To: Alex Nemeth

From: Stephen DiCicco

Date: 7/22/2011

Subject: RAMPP West Virginia LiDAR QA/QC: Coal River Delivery

Figure 2- Northern portion of the Coal River delivery. Four small portions of the greater West Virginia project area are not covered by Coal River tiles.

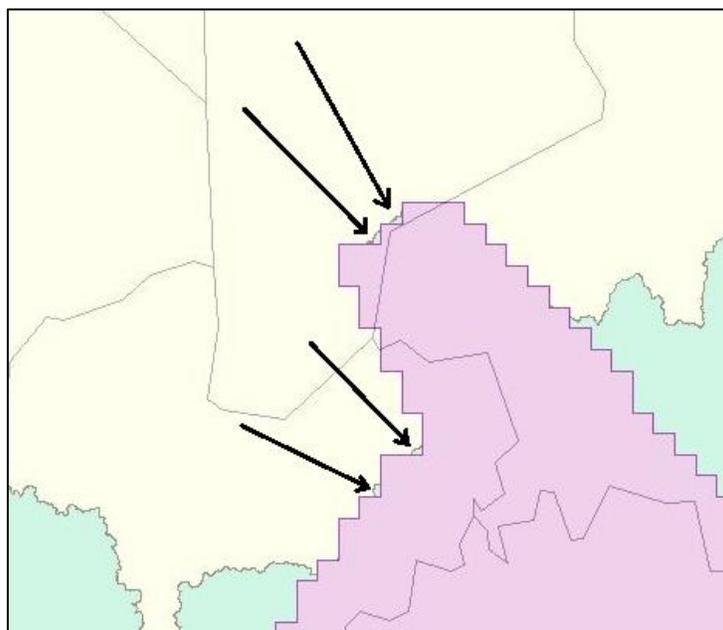
Figure 2 shows a close up view of the Coal River delivery overlaid on the West Virginia area of interest. The northernmost portion of Coal River tiles borders the area of interest but falls short in four places. These gaps range from 0.1 to 0.2 mi². Though not an error, trajectories show that LiDAR was flown for these gaps. Processing these portions with this delivery, if they are to be processed, would have been most efficient.

Figure 3- The LiDAR points exceed the tile boundary by approximately 10 m.

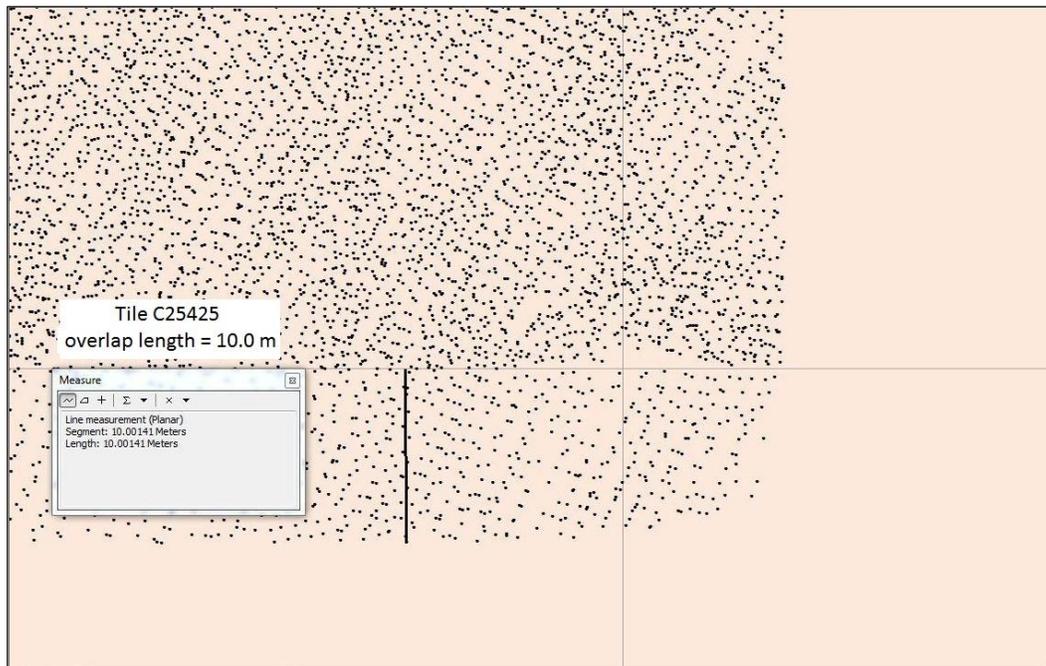
The LAS tiles overlap each other and the West Virginia tile scheme by approximately 10 meters on all sides. Figure 3 shows LAS tile C25425 converted to an ESRI multipoint file and overlaid on the project tile scheme. The overlapping portion of points which extends past the tile boundary and is duplicated by the neighboring tiles is measured at 10.0 m in length. This is not consistent with the scope of work which specifies seamless tiles. As discussed subsequently in the LiDAR QA/QC section of this report, the LAS overlap also causes classification errors along tile seams. The tiles should be trimmed and edges should be inspected for remaining artifacts.

Figure 4 - A profile from LAS tile C21975 colored by flight source ID. A flight line offset which measures up to 1 m is visible.

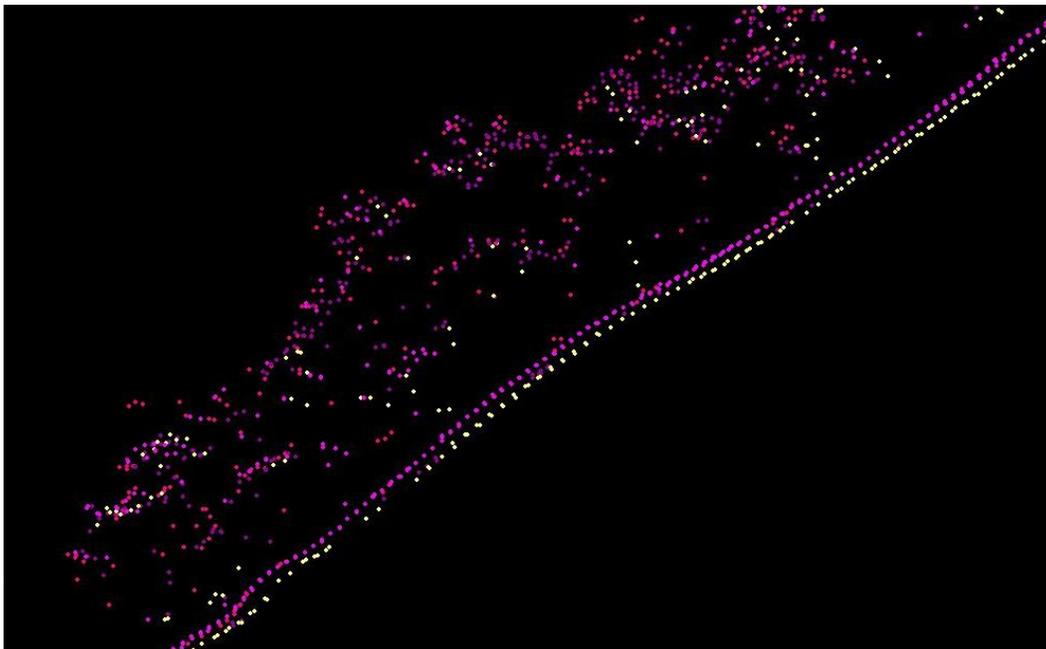
Flight trajectories for the Coal River delivery show sections of dense overlapping flight lines which are assumed to be re-flights. Several flight line offsets were detected in areas where multiple flight lines overlap; primarily the re-flight areas. Figure 4 shows a profile from tile C21975 colored by flight source identification. Pink and purple points (which appear similar) are from flight lines s_173 and s_374 respectively. Yellow points are from flight line s_121. Flight line s_121 is up to 1 m lower than the other two.

In some cases, like in Figure 4 the flight line offset is “classified out” meaning the lower of the two lines was classified to ground and the upper to unclassified. This may affect the absolute vertical accuracy of the data if tested in this location. Additionally, noise and flight line ridges which can be attributed to the flight line offsets are seen in the ground models.

Figure 5 - Delta-Z ortho images for several West Virginia tiles with flight line trajectories shown in yellow. Red indicates a flight line offset may exist. Areas containing the greatest amount of red correspond to re-flight and trajectories.

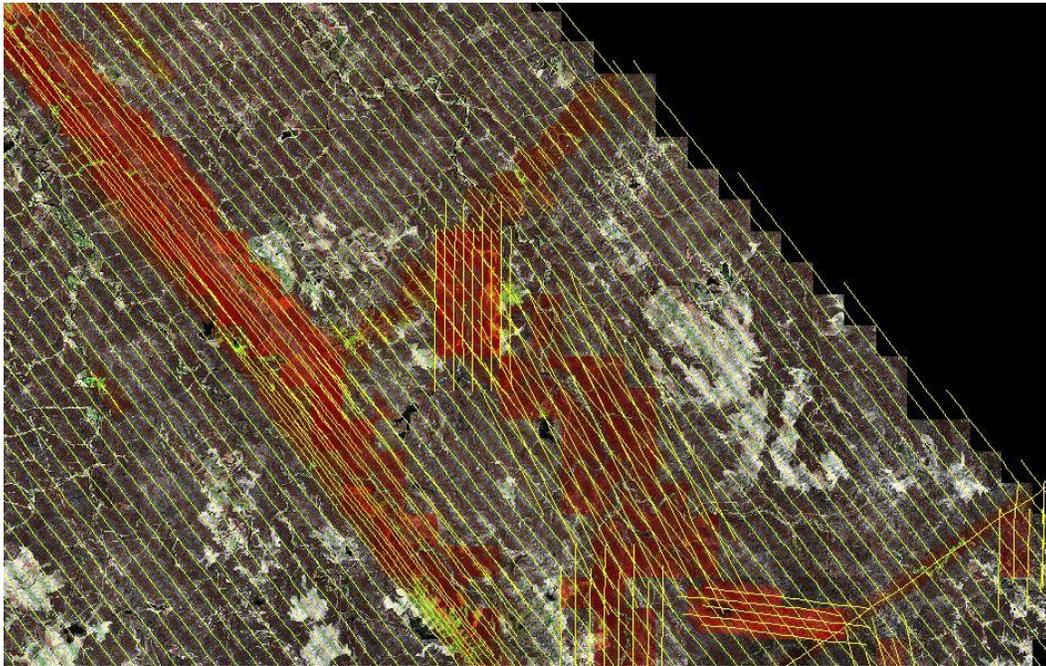
Figure 5 shows a mosaic of Delta-Z ortho images created using only first return points. Overlaid are the flight line trajectories. The red tiles are an indication that a flight line offset may exist. Areas containing the greatest portion of red clearly correspond to re-flights. RAMPP recommends all tiles containing re-flight trajectories be examined and corrected for flight line offsets. Some flight lines along which offsets are known to exist include:

- s_363 s_158 s_169 s_148 s_414 s_151 s_378 s_121 s_375
- s_364 s_159 s_559 s_149 s_152 s_111 s_122 s_380

Figure 6- A profile from LAS tile C23751 colored by flight source ID. The landscape has changed significantly between flight dates.

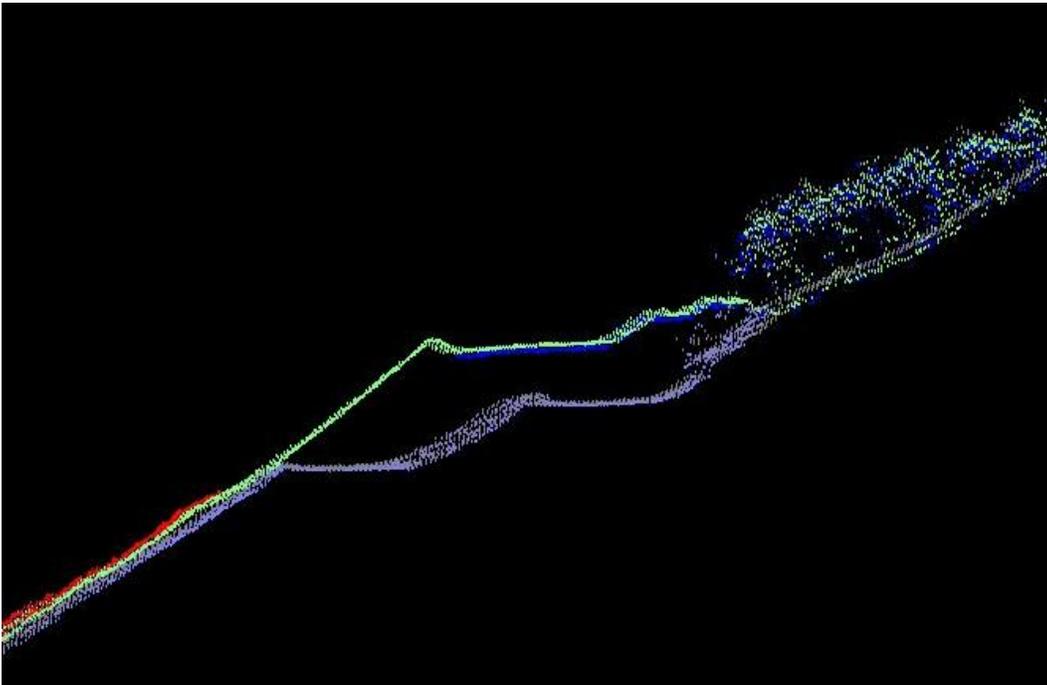
Also noted within tiles covered by re-flights were actual changes in the ground which occurred between flight dates. **Error! Reference source not found.** shows a profile from LAS tile C23751 colored by flight source identification where mining has altered the shape of the ground significantly. In these cases, the more recent depiction of the ground should be consistently classified. Classifying flight lines depicting different ground conditions together contributes to flight line ridges and noise and will add uncertainty to the vertical accuracy calculation. RAMPP recommends checking any tiles with a large span of time between its start and end flight date for significant temporal changes.

Figure 11- Tile C22728 shows a line of vegetation artifacts along its overlapping edge.

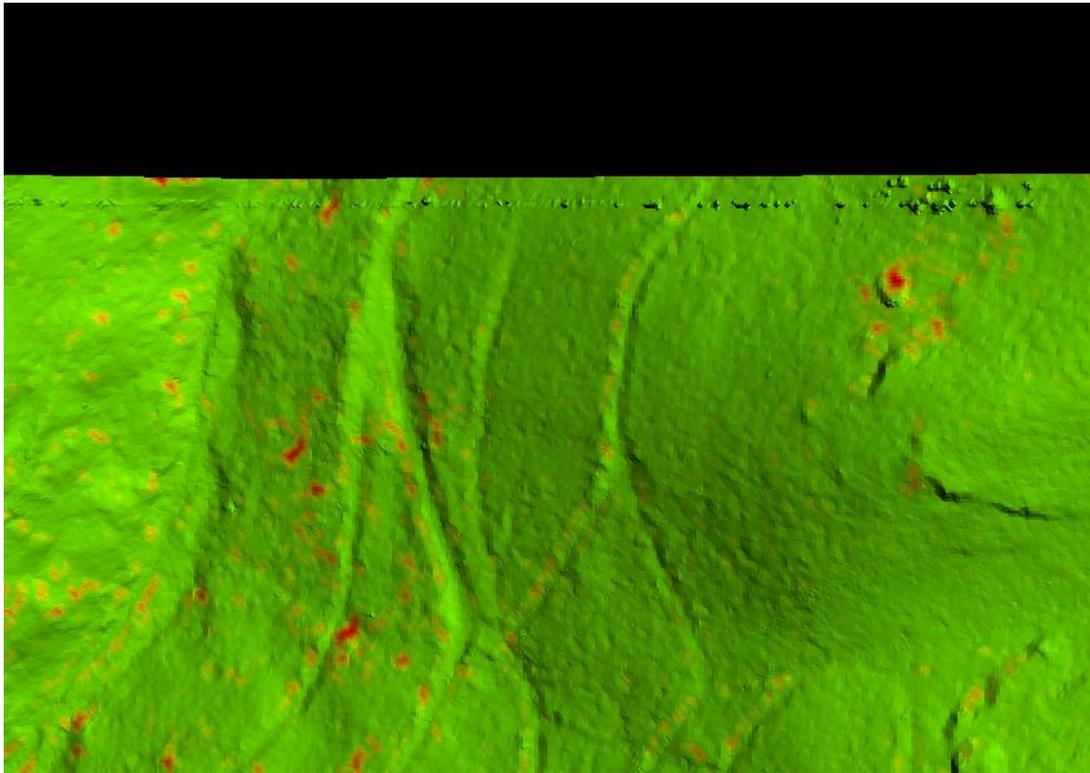
Overlap in the tiles resulted in inconsistent editing along tile edges. Generally the main 1.5 km portion of the tile was classified while the overlapping portion was not. This left a line of artifacts along the edge of the tile ground models. Figure 11 depicts the line of artifacts left in the ground density model of tile C22728. All tiles contained this error along all or some of their edges. The tiles should be clipped then reviewed for remaining artifacts along seams.

Figure 12 – A ridge formed by the overlap between tile C23751 and its neighbors. This signifies a flight line offset.

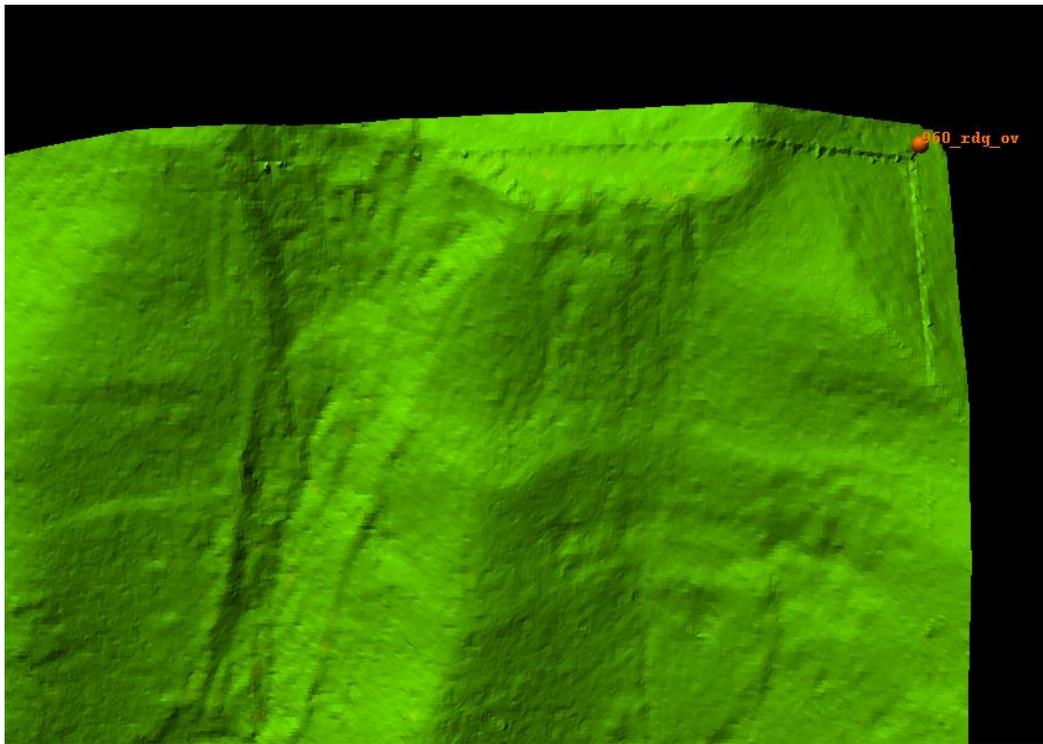
In very limited cases, a ridge appeared in the overlapping portion of the tiles. This signifies a change in ground elevation from one tile to the next and is likely a result of flight line offsets. Figure 12 shows a ridge in the overlapping corner of tile C23751. This tile was used previously to depict a significant temporal change and is known to contain flight line offsets.

Figure 13 – A data void on the overlapping edge of tile C24832. This will be filled by the overlap of the tile above.

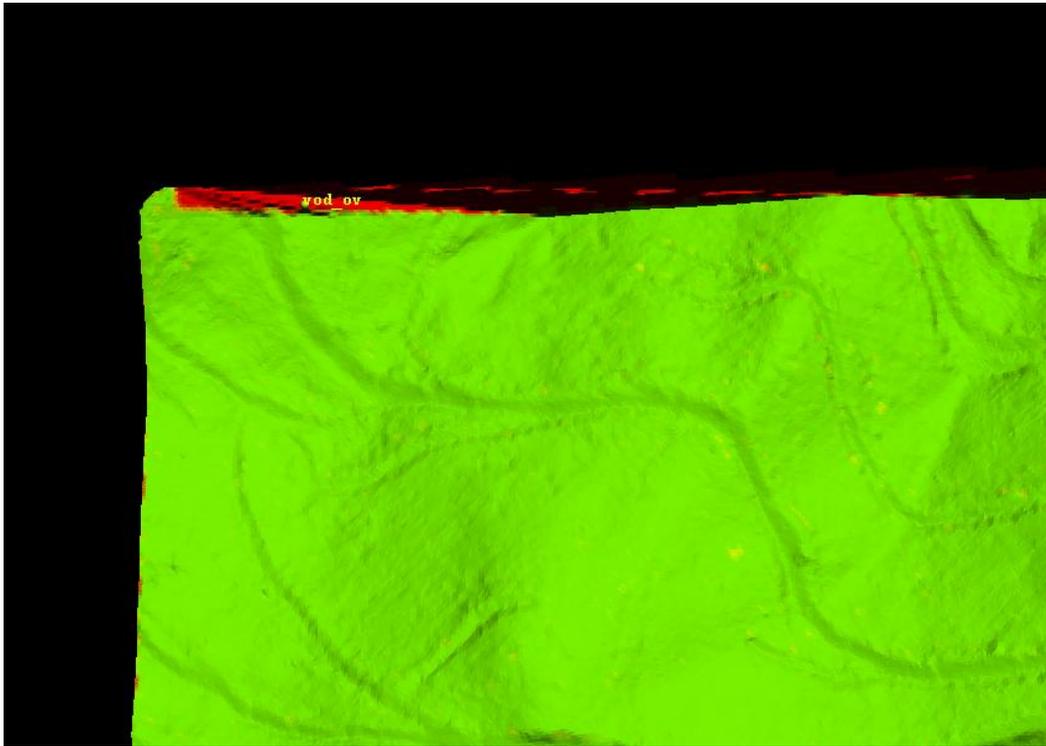
In limited cases, a void was present on one more tile edges. These are not actual data voids but are a product of the tile overlap. No data voids were found in the full point cloud Delta-Z ortho images meaning these voids will be filled by the overlap of neighboring tiles. Figure 13 depicts one such void in red for the ground density model of tile C24832.

Figure 14 – A large building artifact left in the ground density model of tile C18075.

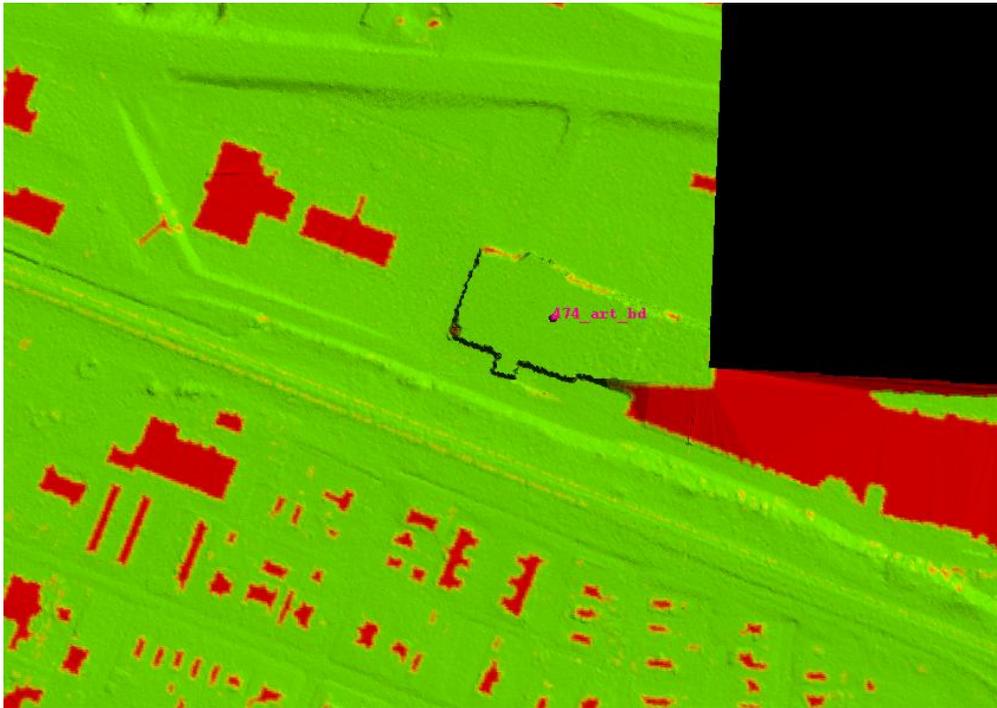
A small portion of artifacts including buildings, bridges and vegetation which exceed the specified maximum of 20 cm and will impact the ground model were left classified into ground. Significant artifacts were marked according to their type. Large artifacts should be reclassified. Figure 14 shows a large building left classified in ground for tile C18075. This was the largest artifact found in the five percent review.

Figure 15 – A large divot in the ground elevation model of tile C23321.

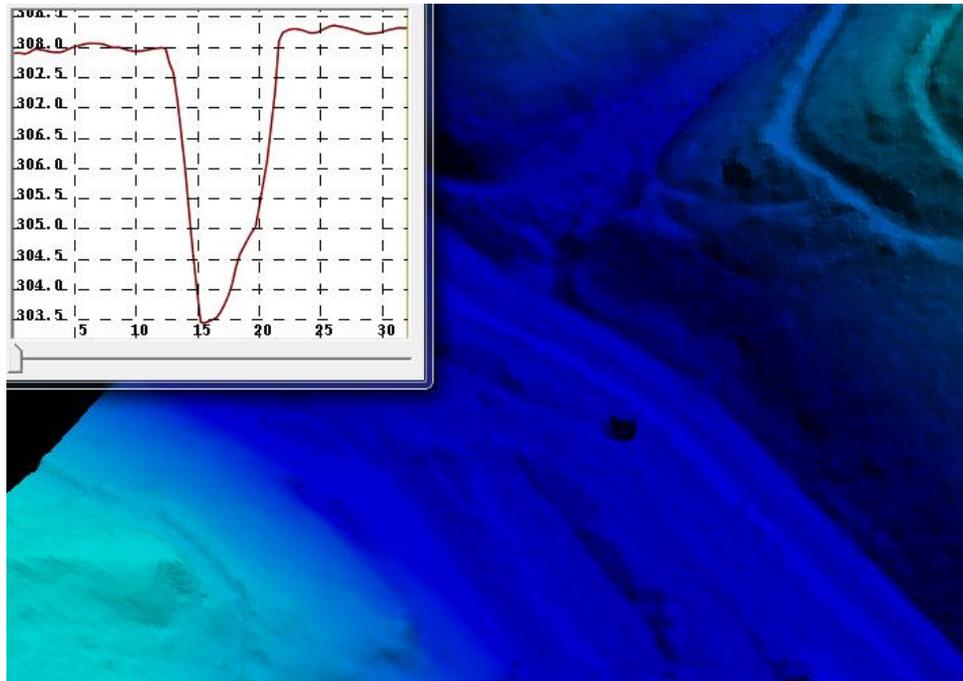
Also typical of LiDAR, several small divots were noted in the ground models. These do not have a significant effect on the ground model. Only significant divots were marked. Figure 15 shows an example of a significant divot. Few large divots were identified.

Figure 16 – An unnatural hole in the ground model of tile C24029 caused by misclassification of ground points to unclassified.

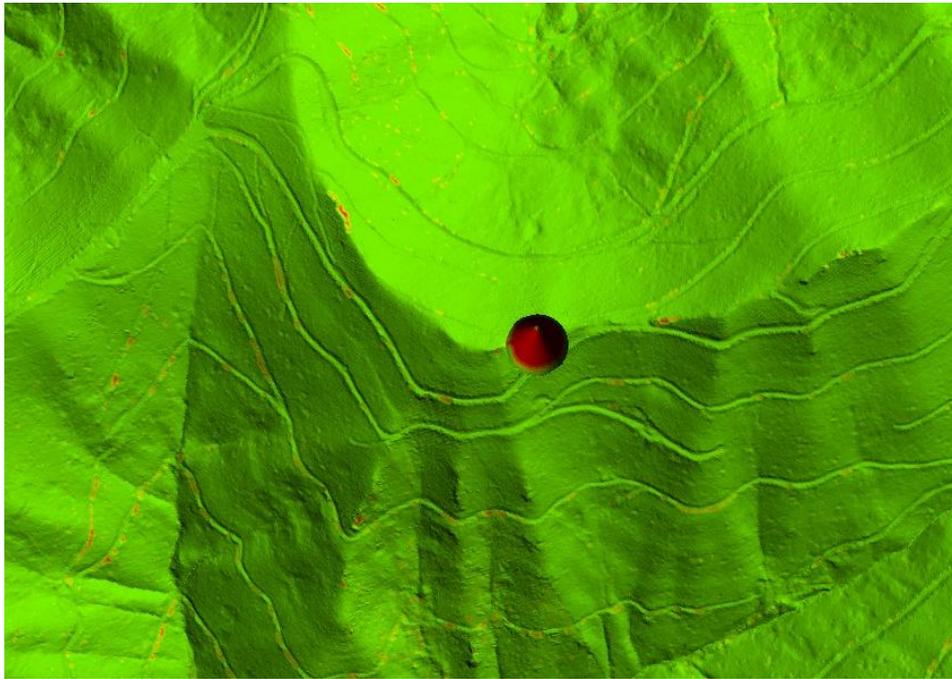
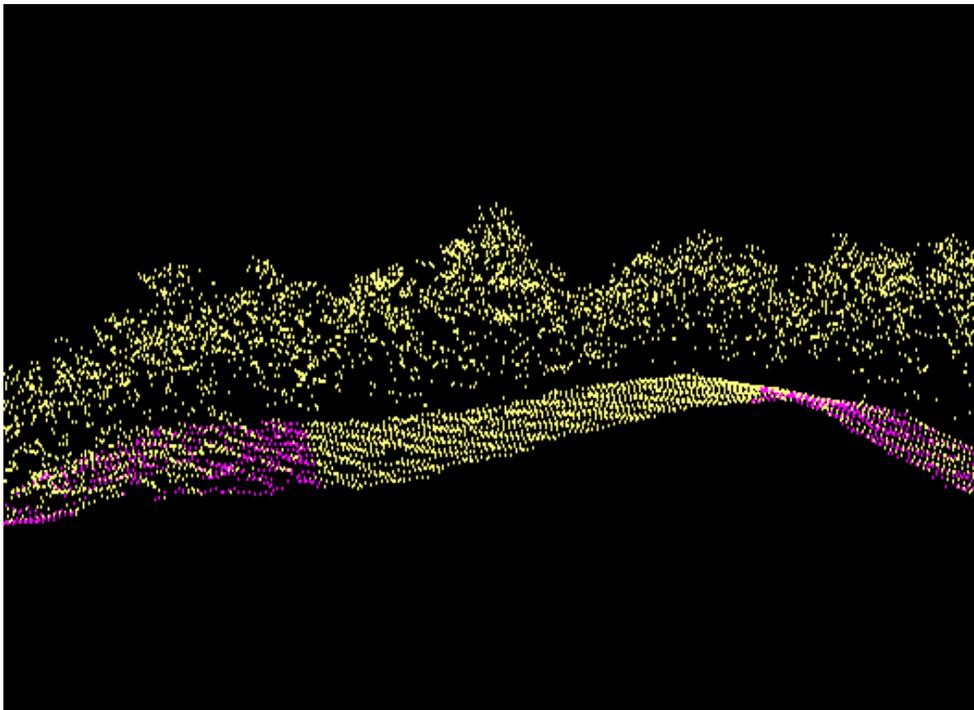
Both major and minor misclassifications of ground points were observed. Two large circular holes were noted where ground point were misclassified into class 1. Figure 16 shows this misclassification as it appears in the ground density model. Figure 17 shows a profile of the LiDAR points colored by classification. Ground points are shown in pink, unclassified points in yellow. The mistaken classification of points in the circular area is clear.

Figure 18 – A profile from LAS tile C26638 colored by classification showing misclassification of ground points to noise. Pink is ground; yellow is unclassified and white is noise. Misclassified noise points towards the center of the profile are clearly in line with the ground.

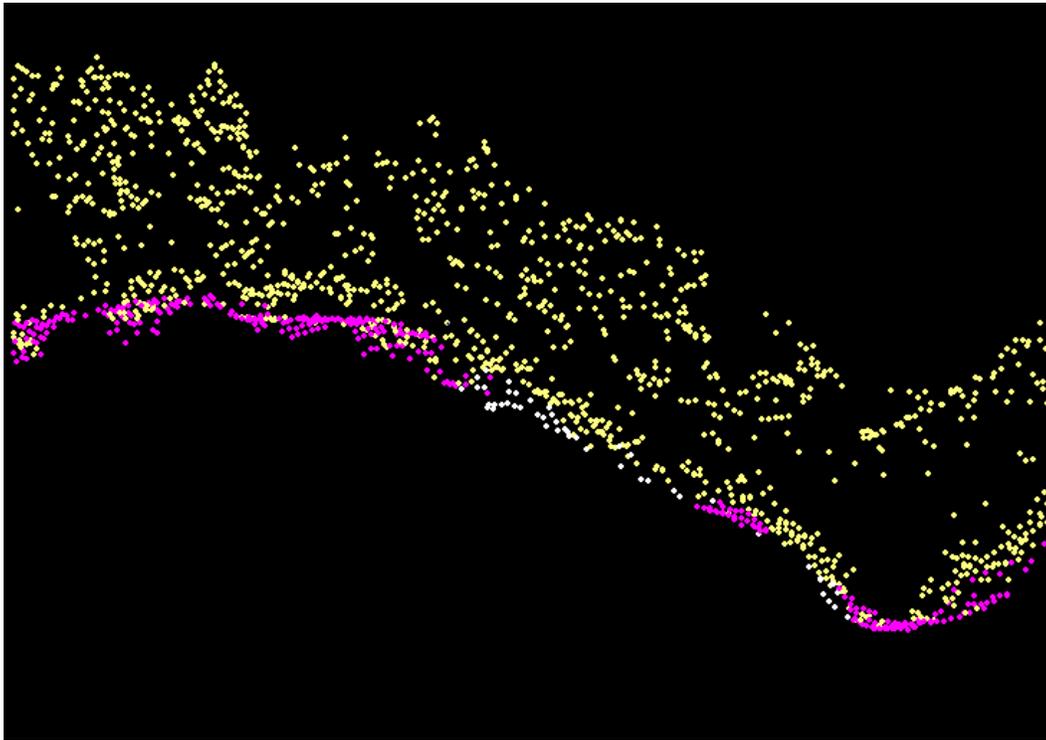
There are several occurrences of misclassifying points to class 7, noise, in the data. Several areas of low point density which appeared to be caused by poor LiDAR penetration actually contain clear ground points which are misclassified into noise. Figure 18 shows LAS points colored by classification for a forested area where ground points are misclassified to noise.
